Office Action Summary

10/560,703

DETAILED ACTION

Figure 4 of Lee.

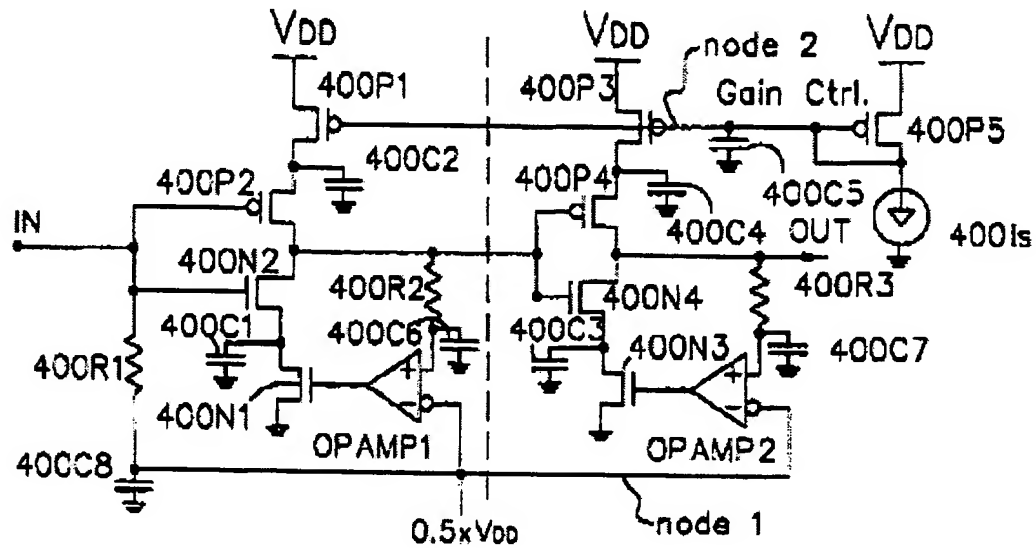
Figure 4 of Lee discloses a low noise amplifier circuit having a CMOS (400P2, 400N2) and a feedback arrangement (OPAMP1, 400N1, 400C1) that is substantially identical to that of applicant's invention (See Figure 11 of applicant's invention.). Lee is silent on the exact construction of the MIS transistors that make up the CMOS arrangement. By being silent, this clearly indicates that any conventional MIS arrangement would work.

Figure 1 of Brunner.

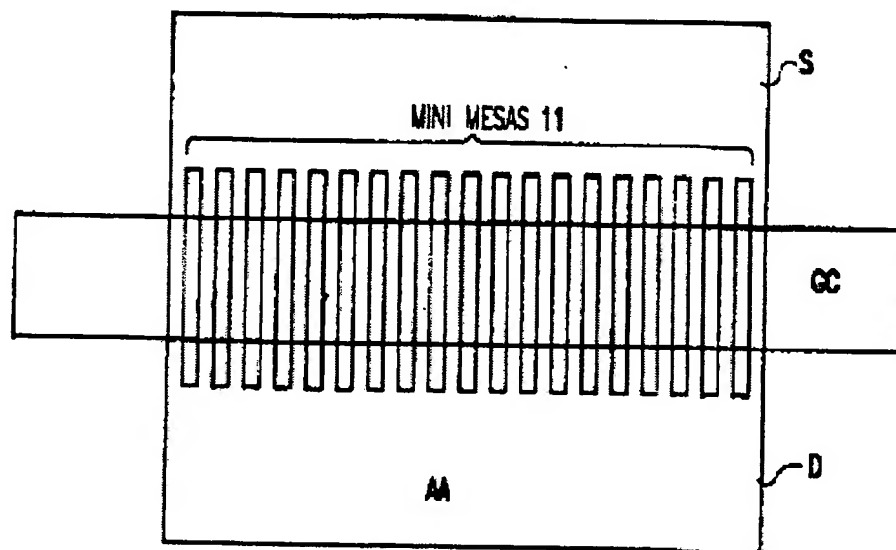
Brunner discloses the specific structure of the MIS transistor as claimed. Of the Figures of Brunner to take note of, Figures 1, 2, 3 and 26 are the most relevant. Applicant should take note that the semiconductor substrate has at least one "fin" that is equivalent to the fin "810A" and "810B" of applicant's invention. Brunner utilizes the term "mesa" for these fins, but the term "fin" is also very common in the art for these transistor arrangements. Brunner is silent on each and every circuit that the transistor can be used in, but the fact is that transistors are meant to be used in circuits, otherwise transistors would not have utility.
